Ref: BHE/PW/PUR/NTPRT-PEB SHED/2167/Corr-01

Sub: Corrigendum-01: Issue of Drawings and clarification

Job: SUPPLY , FABRICATION , MANUFACTURING , LOADING, UNLOADING, TRANSPORTATION, RECEIPT AT SITE AND ERECTION OF PRE ENGINEERED AND RE-ERECTABLE TYPE 6 NO. CLOSED STORAGE SHED (SIZE 60MX15M), FOR 3X800 MW PVUNL PATRATU TPS, Jharkhand.

E- TENDER SPECIFICATION NUMBER: BHE/PW/PUR/NTPRT-PEB SHED/2167

PROJECT:-	
TITLE	:- TENTATIVE FRONT ELEVATION OF CLOSED SHED WITH OFFICE AND C & I ROOM (ABOVE G.L.)
DRG NO.	:- BHEL/PW/PES - COS - 01
OWNER	:- BHEL-PSWR NAGPUR

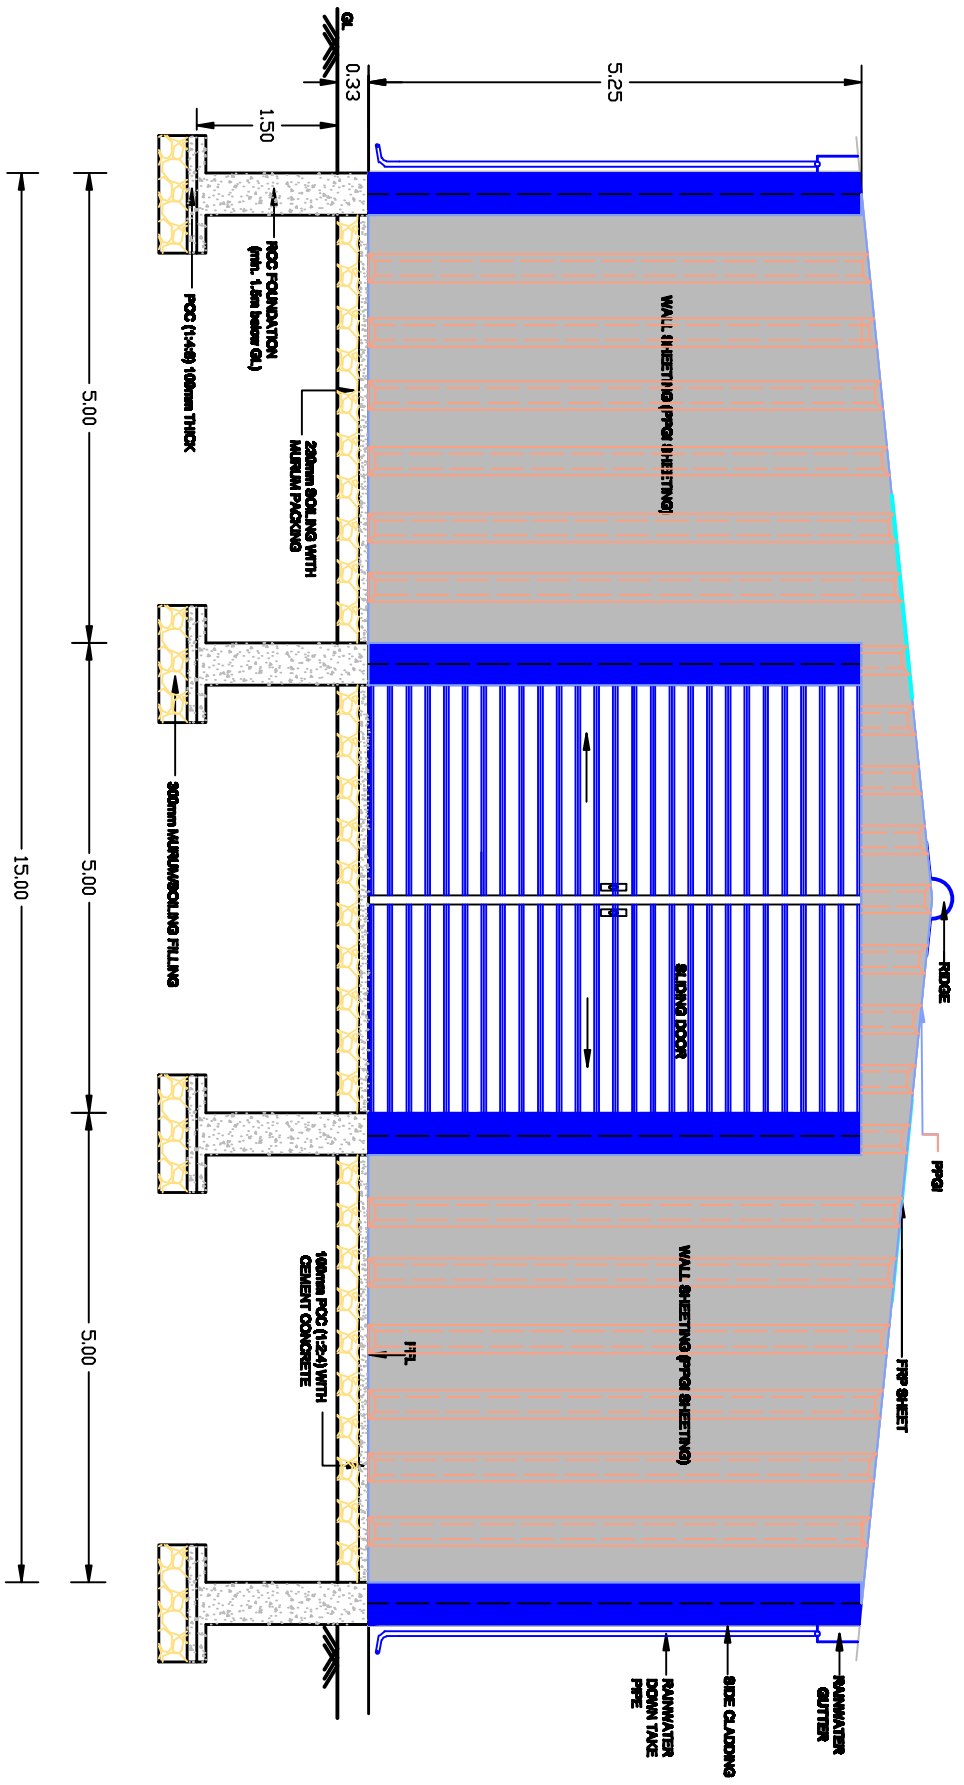
Sl. No.	Bidder's query	BHEL's Clarification
1.	Drawings are not provided and in the BOQ it is mentioned that Structural Steel works should be carried out as per the drawings. Drawings are necessary for calculating the erection cost also.	Tentative drawings are attached with this corrigendum-01 for bidder guidance. It is item rate contract. RFC drawings shall be issued progressively during execution of work.
2.	Height of PEB covered shed is not provided	
3.	Opening locations in the shed is not mentioned	
4.	Should we need to provide brick work anywhere in the shed	Tender conditions shall prevail.
